MEMORANDUM

Department of Building and Planning

RE: Kendall Toyota – Internal Illumination of Entry Wall – Determination of
Architectural Harmony

Illumination Study

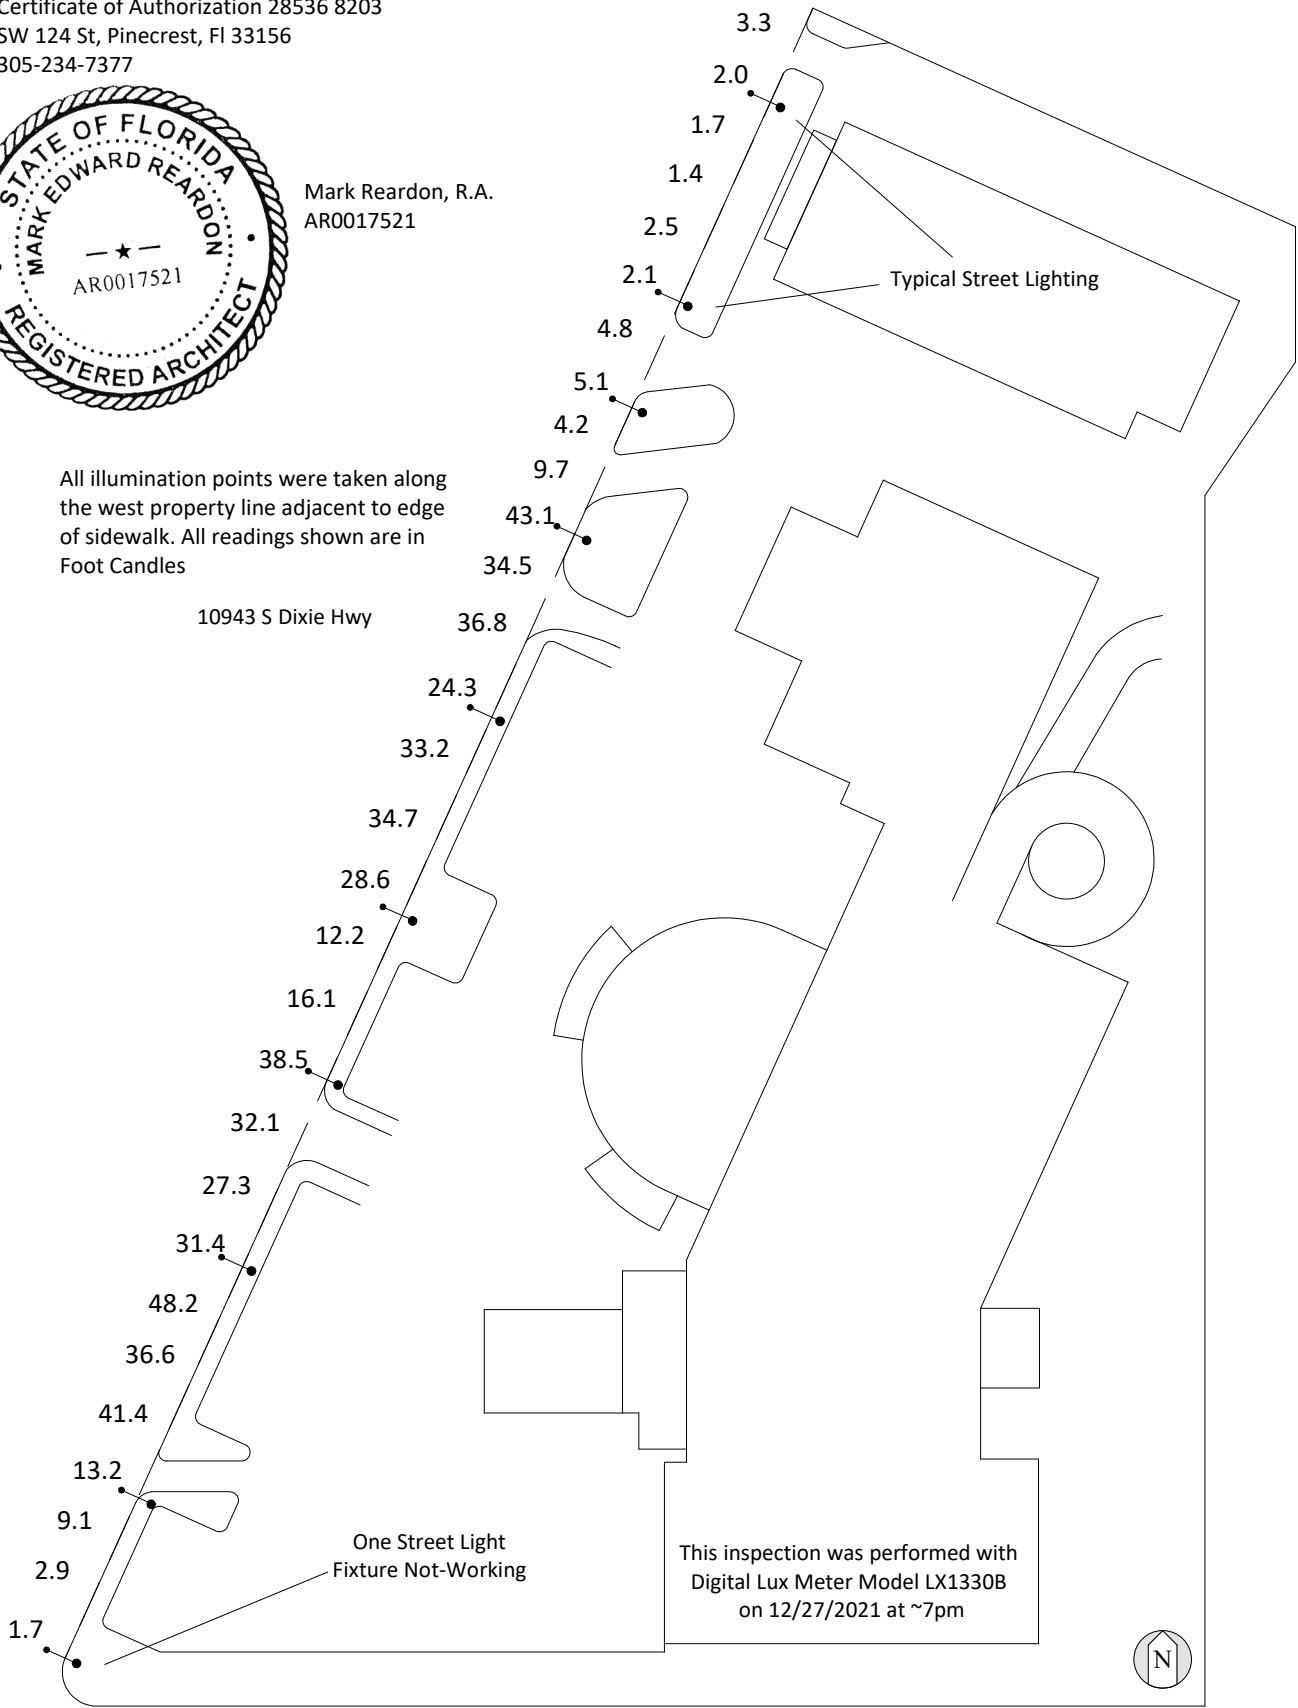
An Illumination Study, completed by Allied on December 27, 2021 (attached) confirms existing lighting levels at the Kendall Toyota property line adjacent to Pinecrest Parkway to be as high as 48.2 foot-candles, or 96.4 times greater than otherwise permitted by code today. Additionally, a recent field inspection completed by the Building and Planning Department has confirmed that several of the existing lights on the subject property are not shielded and are causing glare. The proposed illuminated wall may result in the addition of more lighting intensity to the site that is already non-conforming with regard to existing unshielded lighting fixtures and intensity of lighting at the property line. Recent photographs showing existing lighting conditions on the subject property are provided on pages 9 and 10 of this report.

The existing intensity of glare on the property with multiple unshielded light fixtures, and an intensity of lighting at the property line that exceeds the Village's established maximum

of 0.5 foot candles may be exacerbated with the addition of a lighted façade and would not be consistent with intended and planned “decorative lighting” and “accent lighting” adjacent to Pinecrest Parkway.

Division 5.20 – Non-conformities. Internal illumination of the existing synthetic glass wall may add lighting to the exterior of the property that may increase the existing degree of non-conformity, contrary to Division 5.20 of the Village’s Land Development Regulations. The Land Development Regulations limit lighting at the property line to a maximum of 0.5 foot candles. An Illumination Study completed by Allied on December 27, 2021 (attached) confirms existing lighting levels at the property line adjacent to Pinecrest Parkway to be as high as 48.2 foot-candles, or 96.4 times greater than otherwise permitted by code today.

The proposed internally illuminated wall may result in the addition of more lighting intensity to the site that is already non-conforming in terms of glare and intensity of lighting at the property line. Please refer to the photographs included above and to the attached Illumination Study.
